STATE OF CALIFORNIA - DEPARTMENT OF TRANSPORTATION
 NORTH REGION
 PROJECT MANAGEMENT
 TEAM TAHOE - DESIGN BRANCH 3

Dist	COUNTY	ROUTE	POST MILES TOTAL PROJECT	SHEET No.	TOTAL SHEETS
03	ED	50	77.3/79.3	12	345

REVISED PER ADDENDUM No. 3 DATED OCTOBER 21, 2010

**UTILITY PLAN
GAS AND TELEPHONE**
SCALE: 1" = 50'
U-5

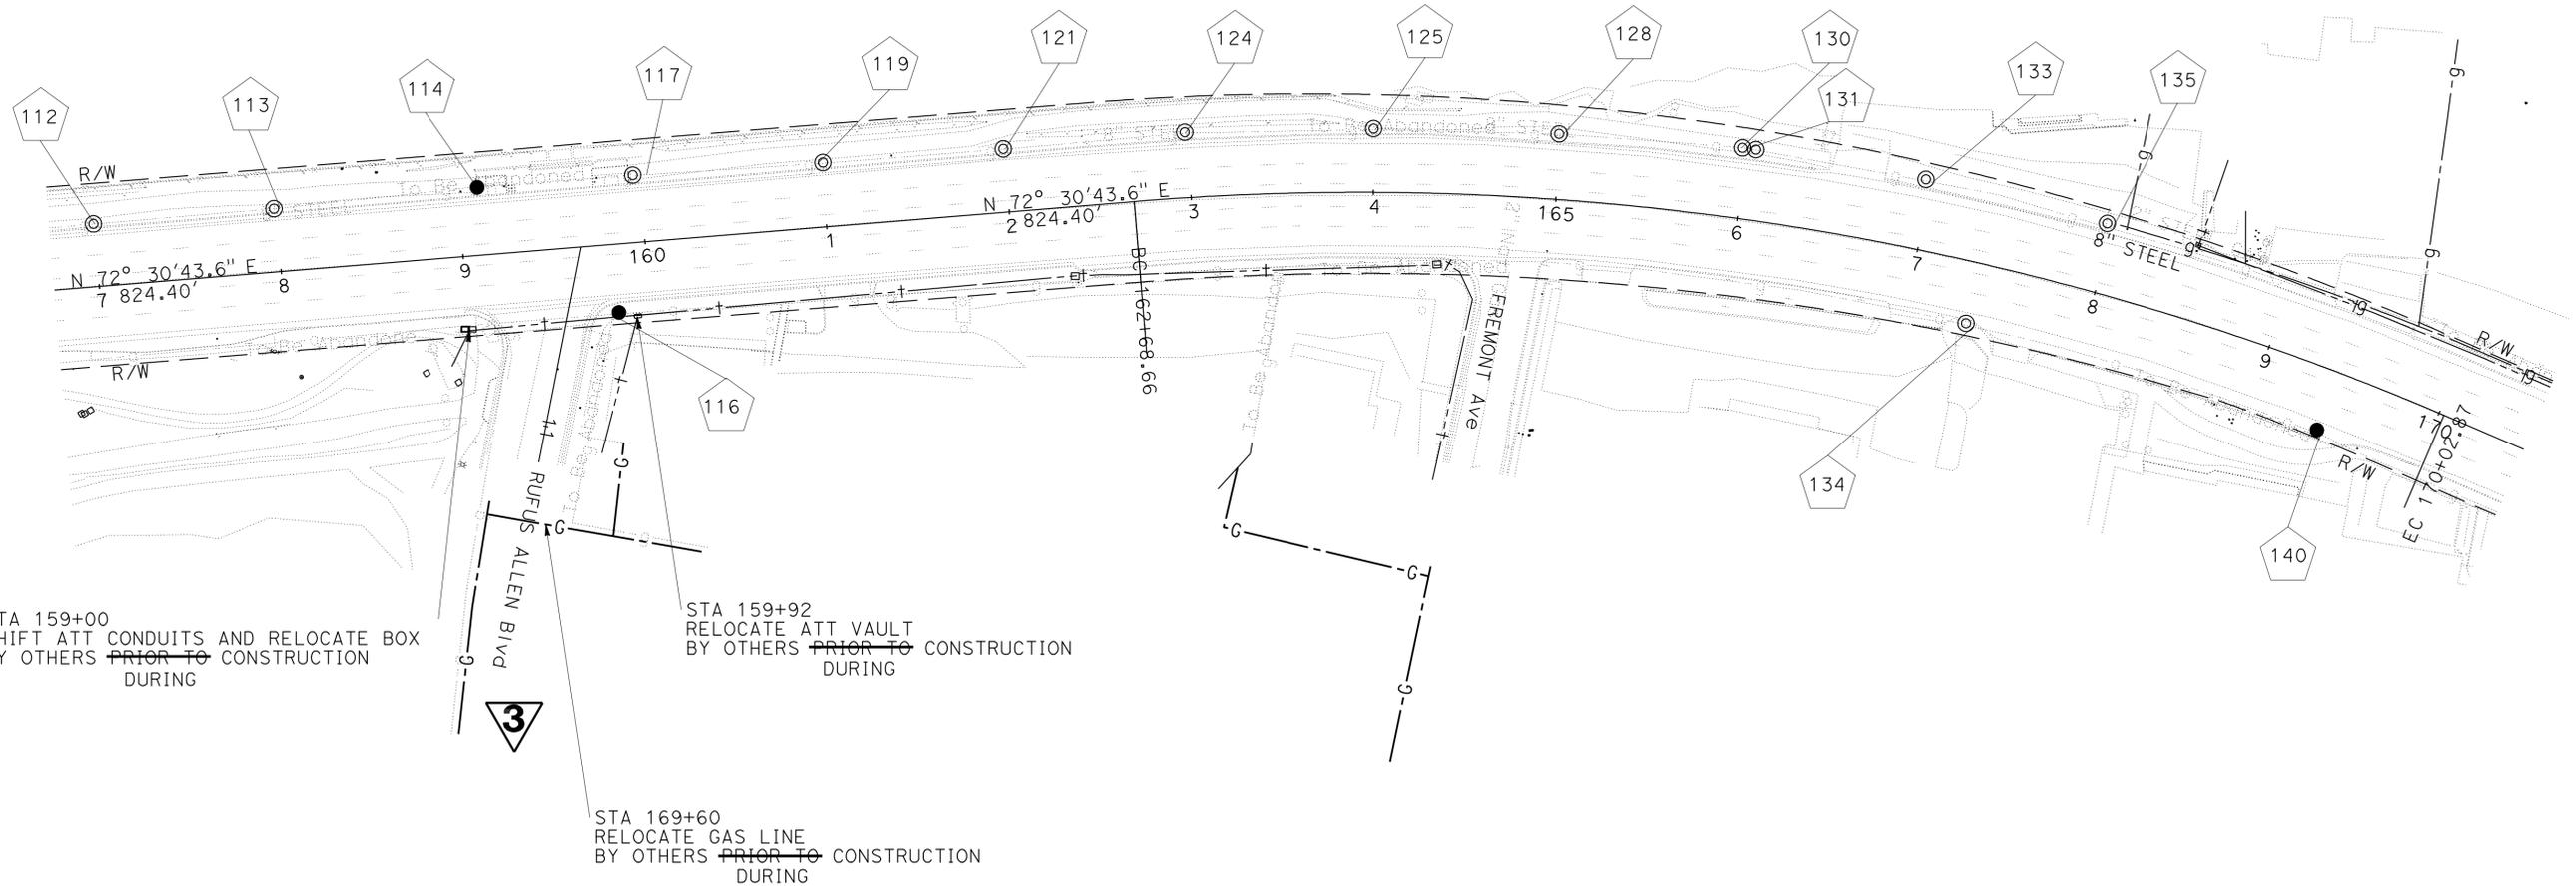
STA 159+00
SHIFT ATT CONDUITS AND RELOCATE BOX
BY OTHERS ~~PRIOR TO~~ DURING
CONSTRUCTION

STA 159+92
RELOCATE ATT VAULT
BY OTHERS ~~PRIOR TO~~ DURING
CONSTRUCTION

STA 169+60
RELOCATE GAS LINE
BY OTHERS ~~PRIOR TO~~ DURING
CONSTRUCTION

SCALE: 1" = 50' **U-23**

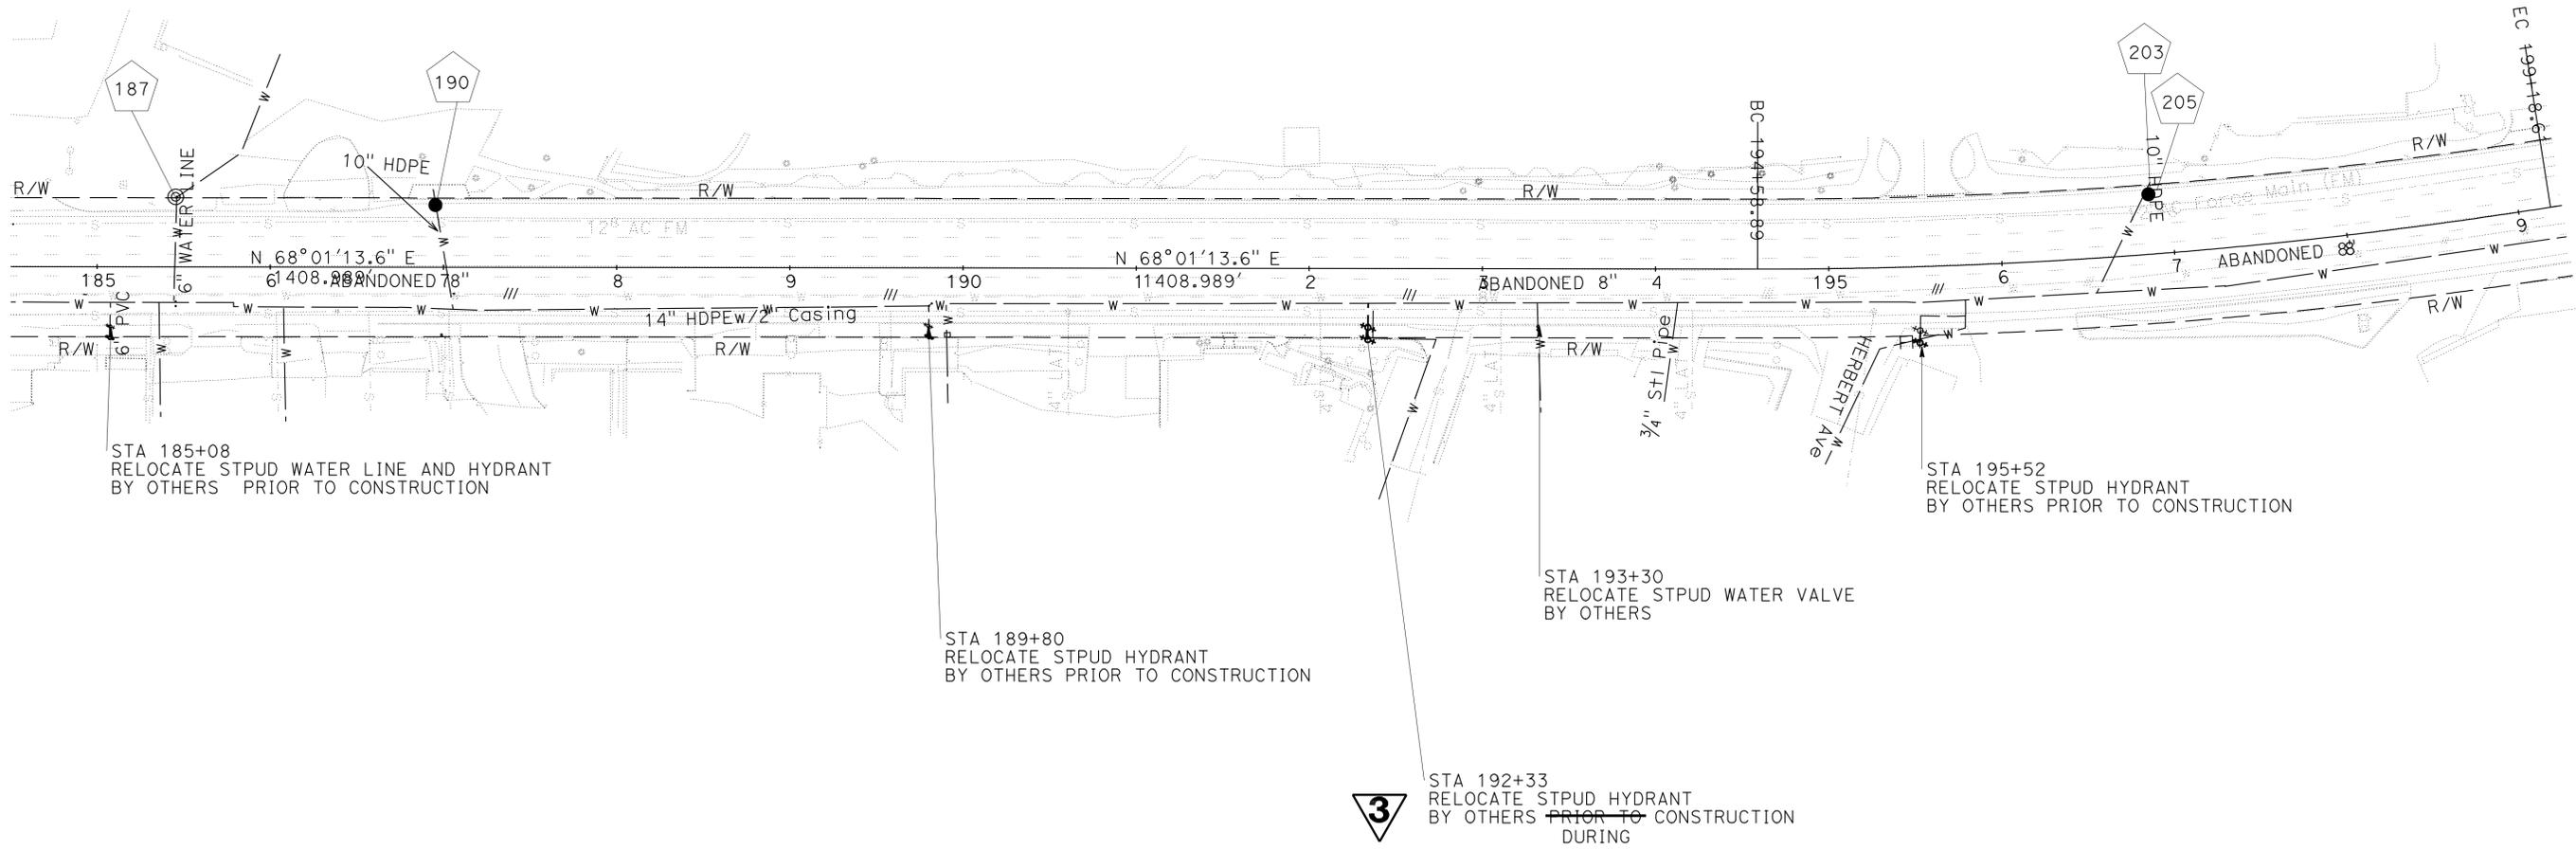
STA 192+33
RELOCATE STPUD HYDRANT
BY OTHERS PRIOR TO CONSTRUCTION
DURING

SC-1

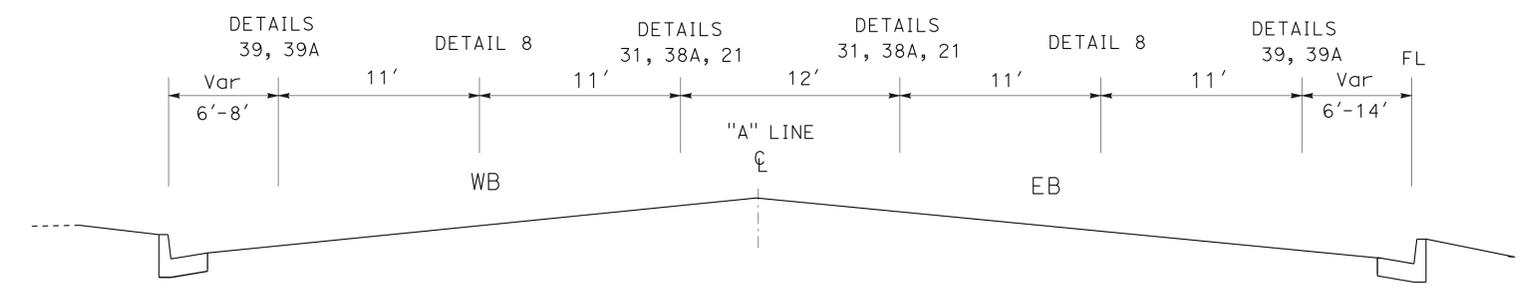
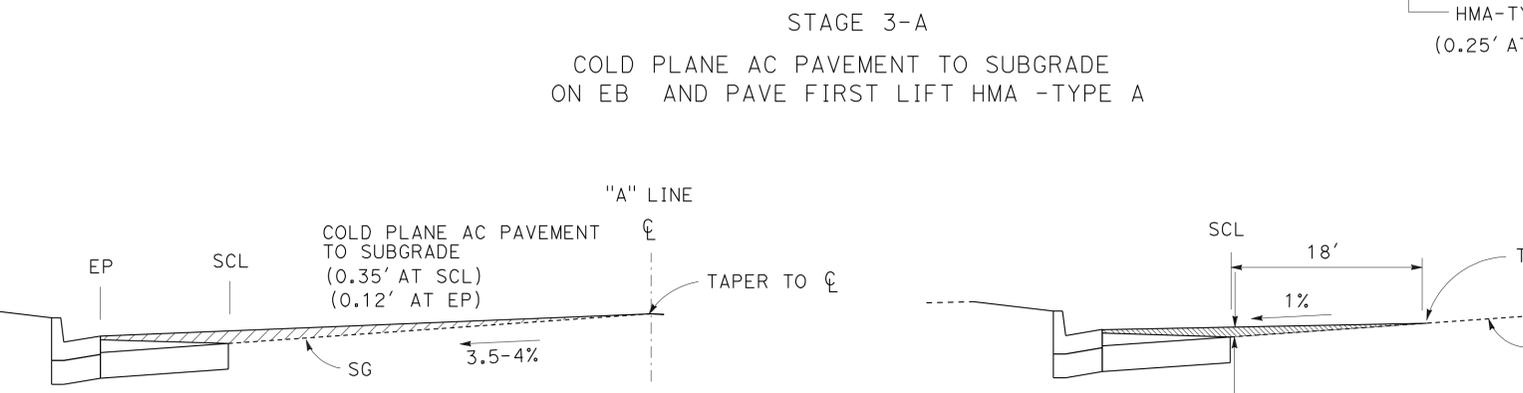
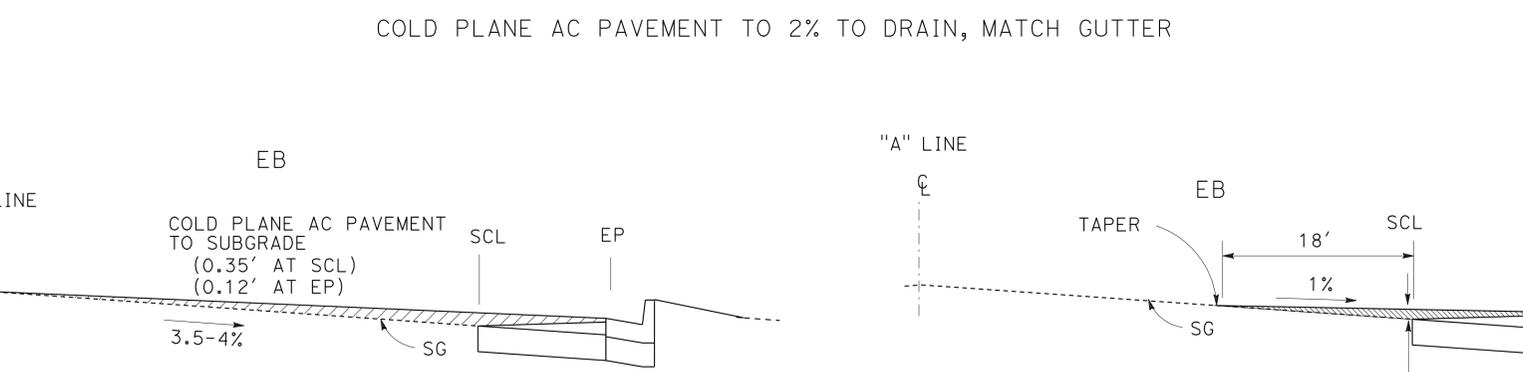
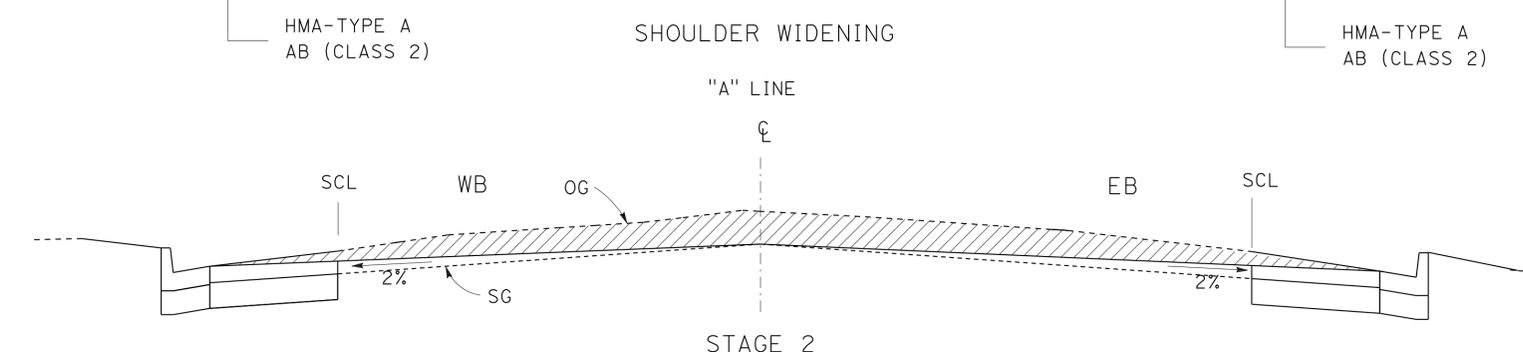
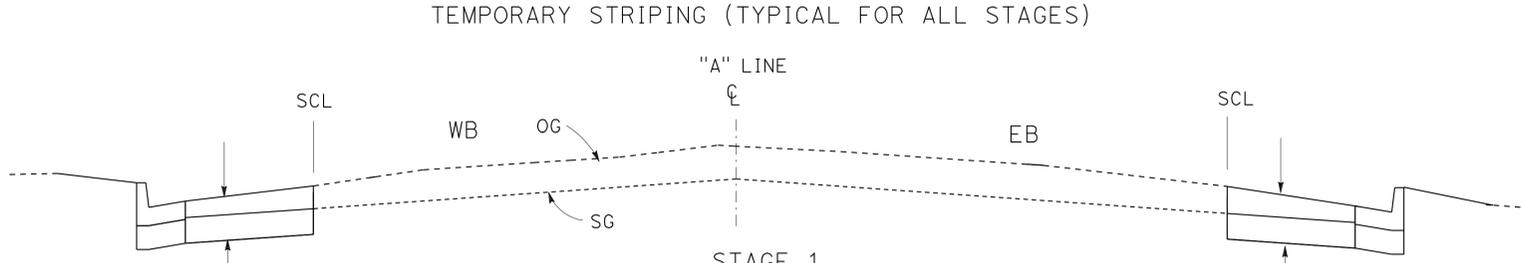
3 ADDED PER ADDENDUM No. 3
 DATED OCTOBER 21, 2010

COLD PLANE AC PAVEMENT TO SUBGRADE
 ON WB AND PAVE FIRST LIFT HMA -TYPE A

SC-2

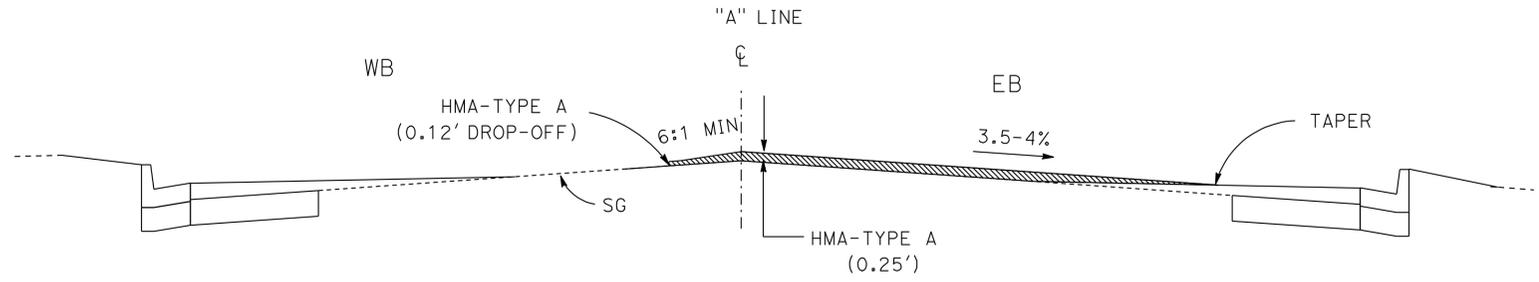
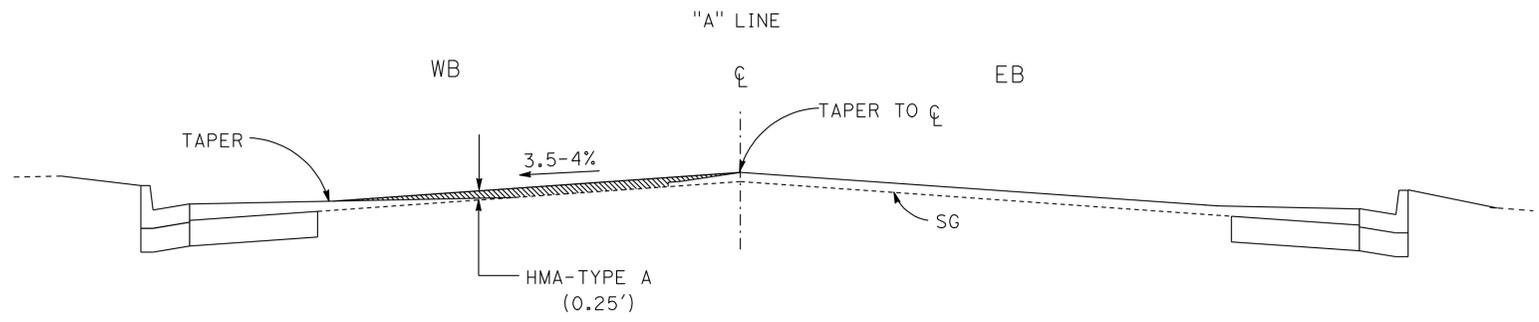
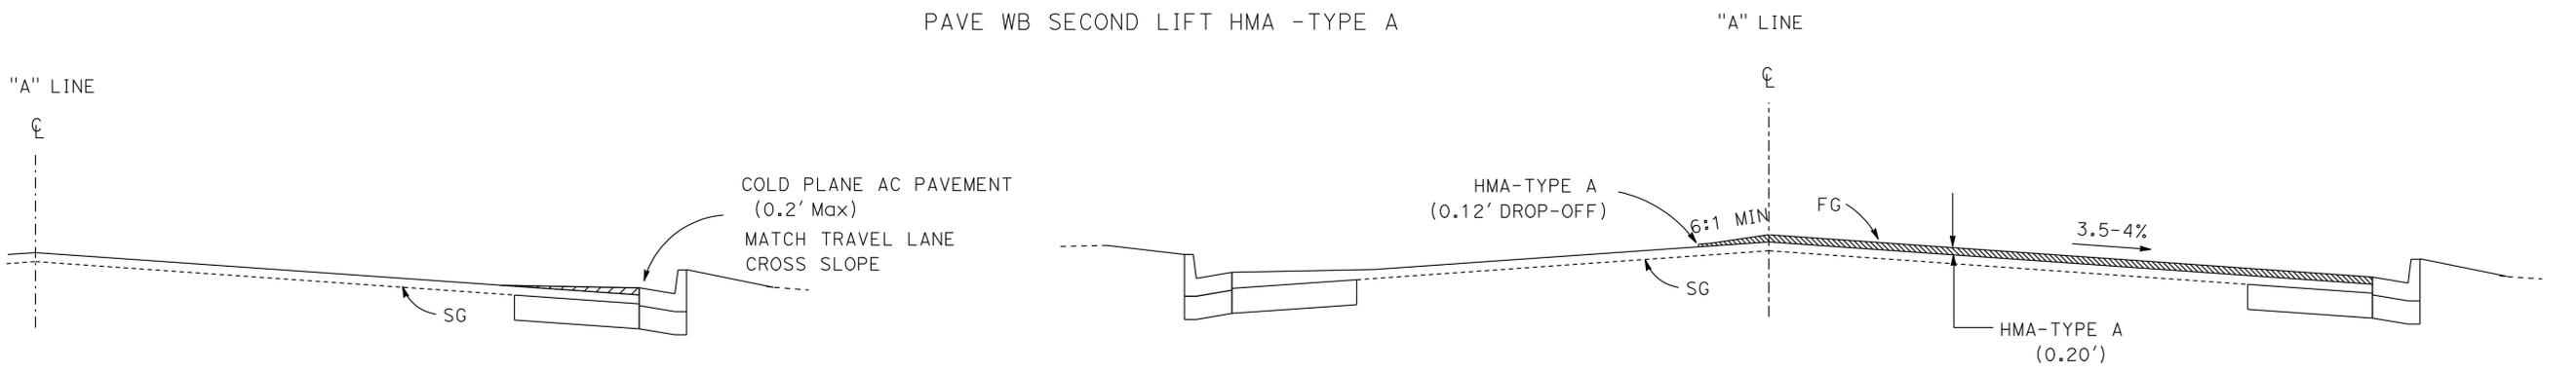
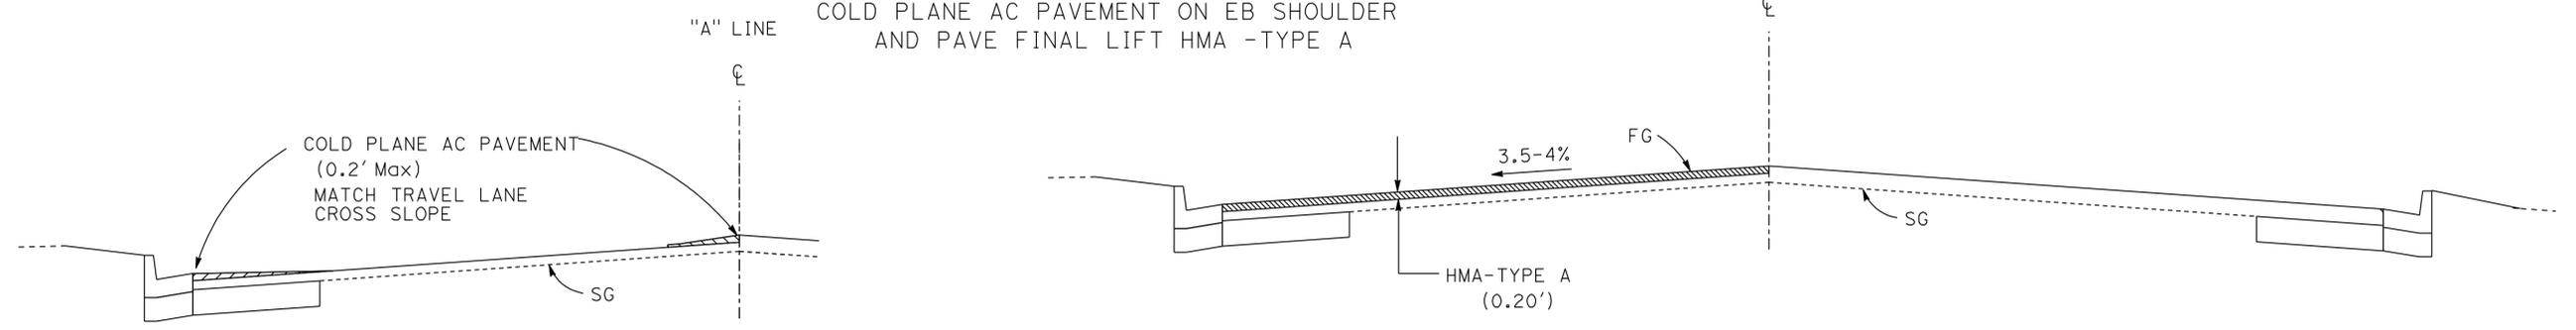
STAGE 4-A
PAVE EB SECOND LIFT HMA -TYPE A

STAGE 4-B
PAVE WB SECOND LIFT HMA -TYPE A

STAGE 5-A
COLD PLANE AC PAVEMENT ON EB SHOULDER AND PAVE FINAL LIFT HMA -TYPE A

STAGE 5-B
COLD PLANE AC PAVEMENT ON WB SHOULDER AND PAVE FINAL LIFT HMA -TYPE A

3 ADDED PER ADDENDUM No. 3 DATED OCTOBER 21, 2010
